Re: Revised Corning Subbasin Groundwater Sustainability Plan

AquAlliance submits additional comments and questions on the revised Corning Subbasin Groundwater Sustainability Plan (“revised GSP” or “revised Plan”) that was made available on April 9, 2024. The 2022 GSP was deemed “Incomplete” by DWR. Serious flaws remain in the revised Plan.

Figure 1. Subsidence in Agricultural Lands Within the Corning Subbasin (5-021.51)

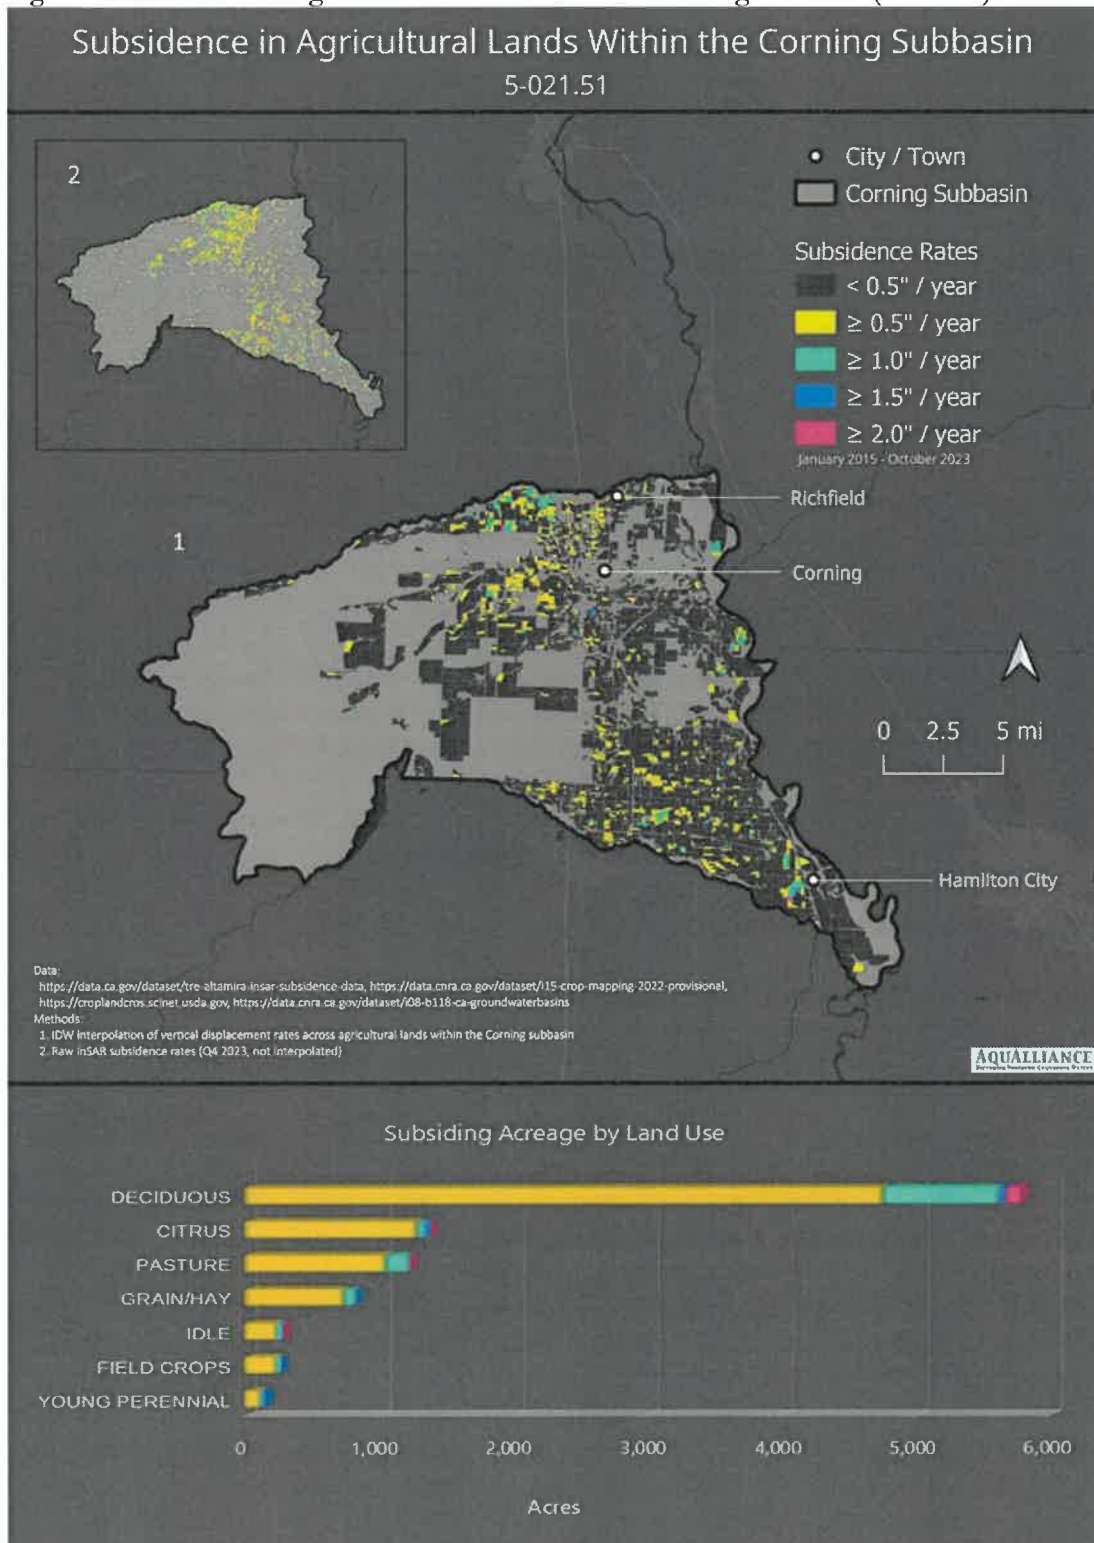
The revised GSP goes on to assert that "Available data indicate that little to no inelastic subsidence has occurred in the Subbasin during the past 2 decades."⁵ Really? The publicly available data used in Figure 1 demonstrate otherwise.

Figure 6-1a. Focus Areas

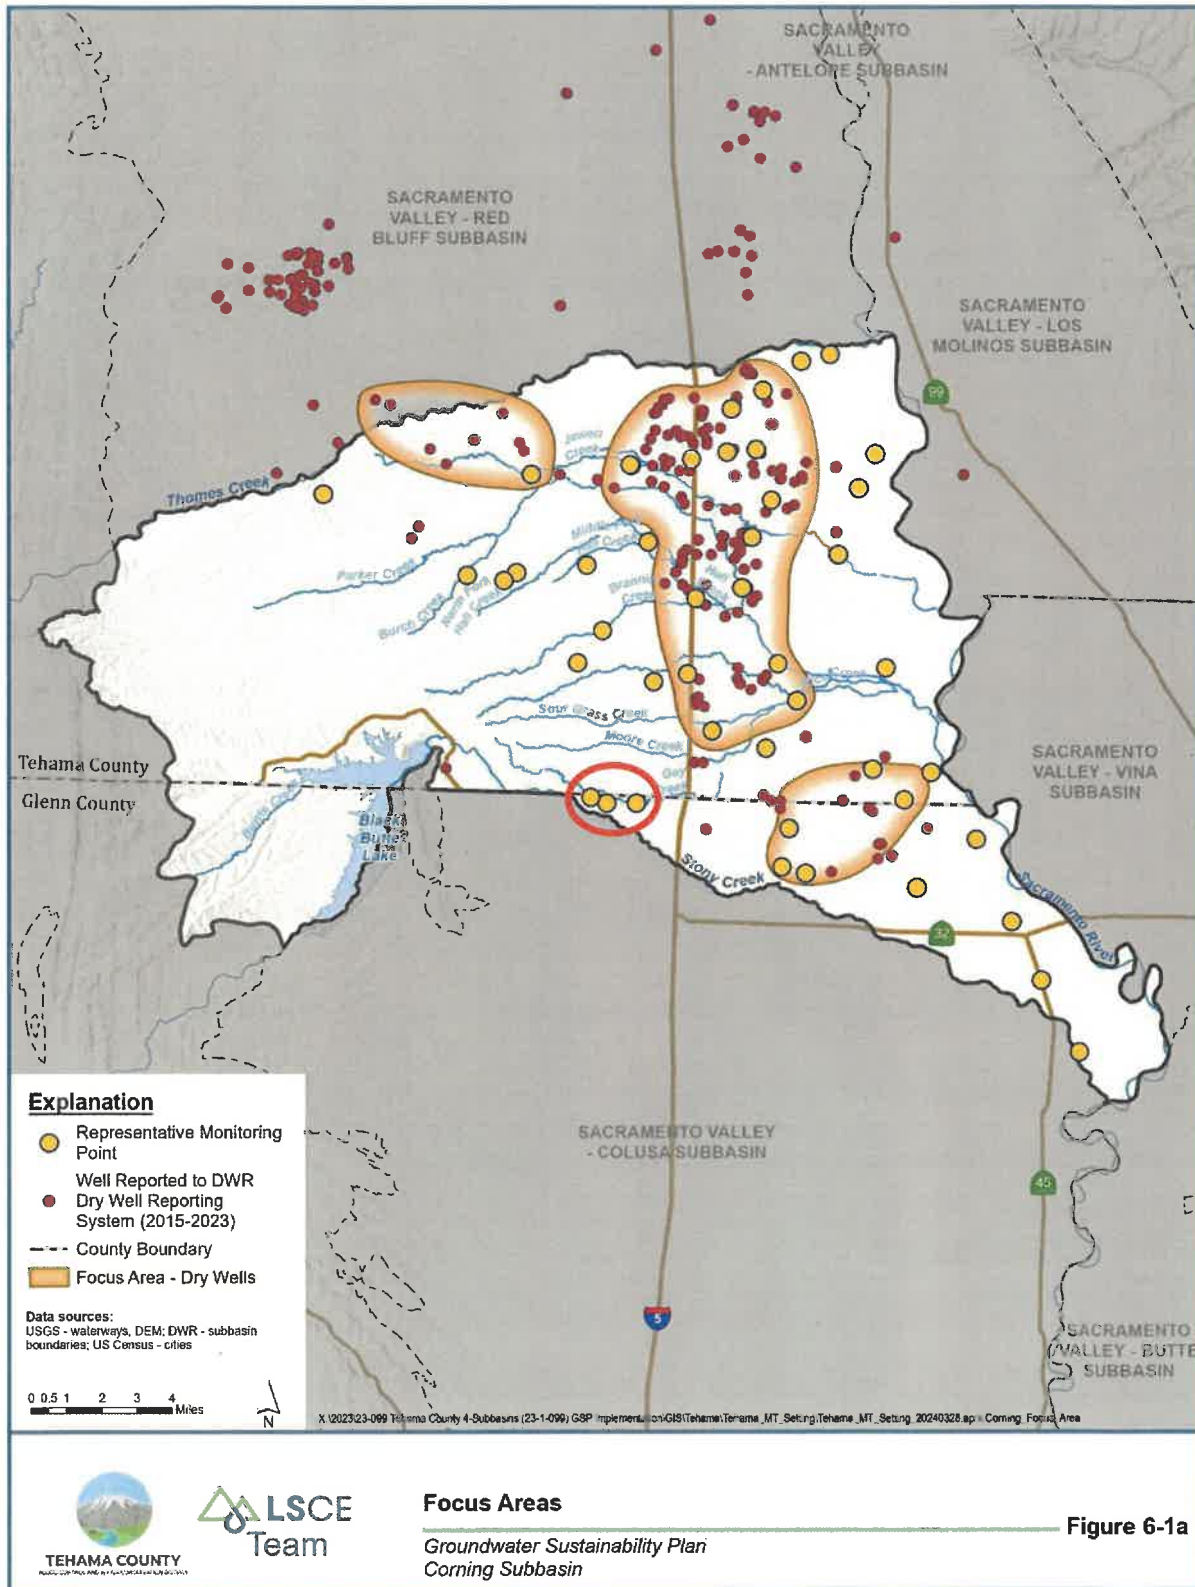
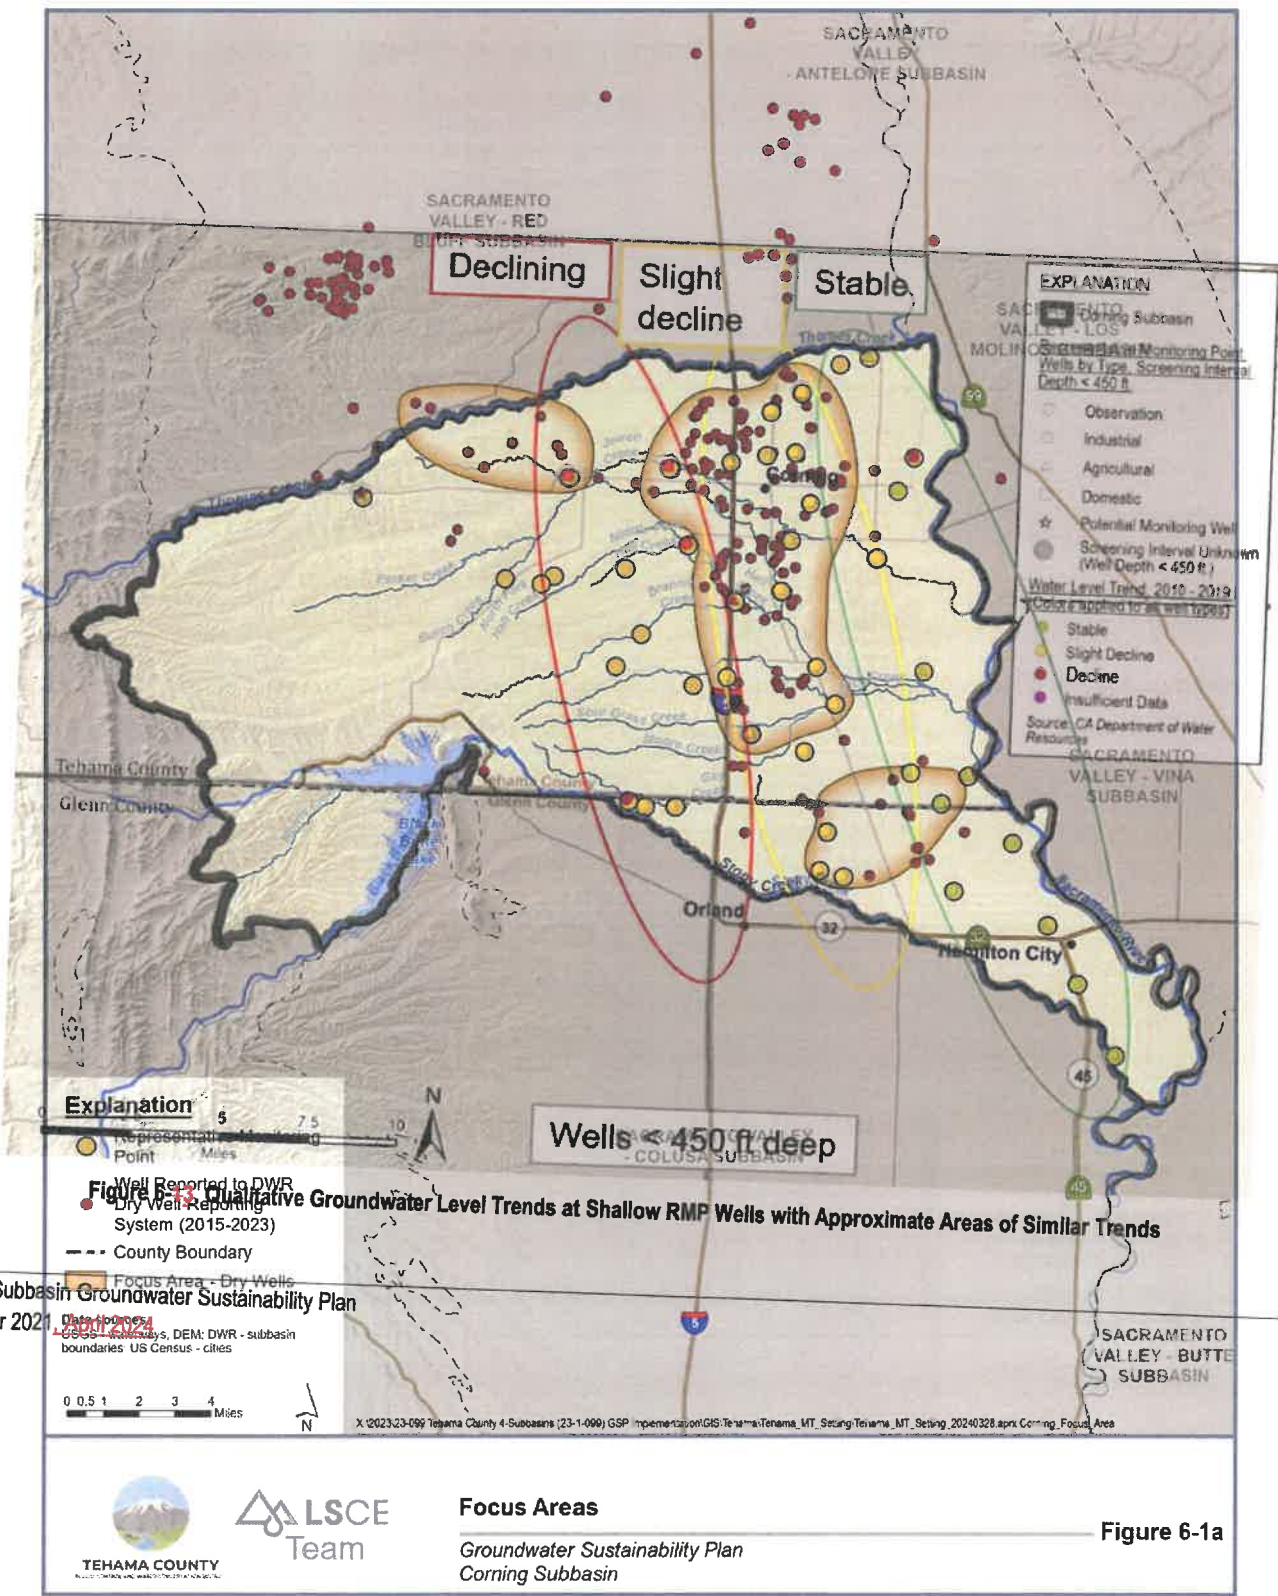
1. Red ovals were added around wells near Stony Creek that are not in the Focus Areas or Zone of Special Concern (pdf p. 424 – Map of Focus Areas, Figure 6-1a).. The reason that these wells are not in a Focus Area or Zone of Special Concern is apparently because the annual average decline in groundwater levels is not faster than 1.5 feet per year (ft/yr), which is the revised threshold of significance for declining groundwater levels. The justification for this revised threshold is stated as:

This setting of the threshold of significance at -1.5 ft/yr seems to contradict the groundwater level trends shown in Figure 6-3 (pdf p. 432). When the attached Figure 6-3 (pdf p. 432) is overlain onto Figure 6-1a (pdf p. 424), which shows the Focus Areas (Zones of Special Concern), most of the dry wells and the areas of the Focus Areas are overlain by the Slight Decline trend area, not by the Declining trend area. The Focus Area in the southeastern portion of the Corning GSP extends into the Stable towards the Sacramento River. The Focus Area in the northwest has only a small portion of its area within the Declining trend area with the majority not included in any groundwater trend area.

Figure 6-1b. Polygons with Declining Water Levels

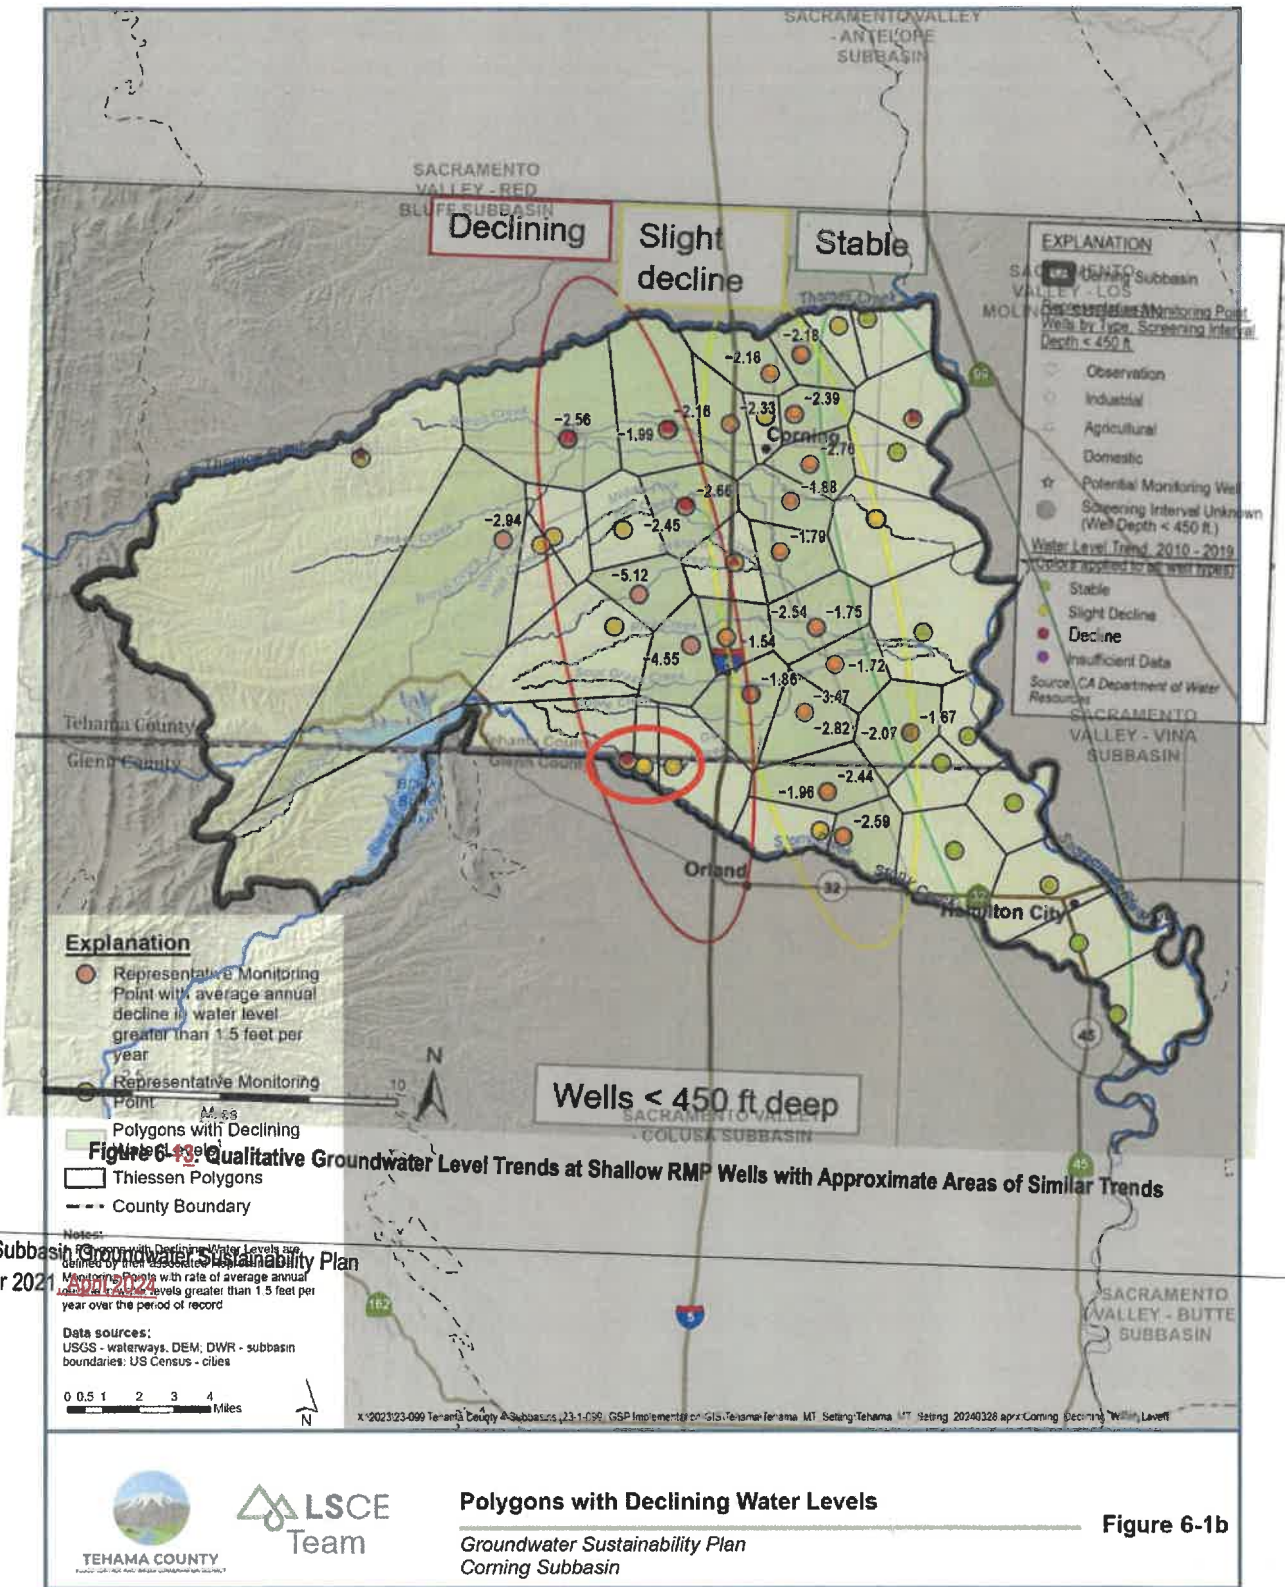
Declining water levels indicate declining groundwater storage. When we look at RMP that have a period of record with 1.5 feet decline per year in Figure 6-1b we see substantial portions of the subbasin appear to have an unsustainable water supply [sic]. The average rates are posted on the figure however short term averages are often steeper, as evidenced in the hydrographs. These polygons are “zones of concern.”

A second attached composite figure shows Figure 6-3 overlain onto the Representative Monitoring Point (RMP) Theissen polygons of Figure 6-1b (pdf p. 425), which gives the value of the average annual decline groundwater levels at the Corning Subbasin RMP wells that are equal to or greater than -1.5 ft/yr. This overlay figure shows that the polygons with declining groundwater levels equal to or greater than -1.5 ft/yr mostly lie within the Slight Decline trend area, not the Declining trend area, even though the greatest annual declining values are within the Declining trend area. Like the Figure 6-3 with the Focus Areas overlay discussed above, there appears to be a disconnect between the areas with the greatest rate of groundwater level decline and the Focus Areas or Zone of Special Concern proposed in the revised GSP. The reasoning for the revised GSP excluding the areas of the polygons with the highest rate of groundwater decline from the Focus Area or Zone of Special Concern isn't clearly explained in the revised GSP.
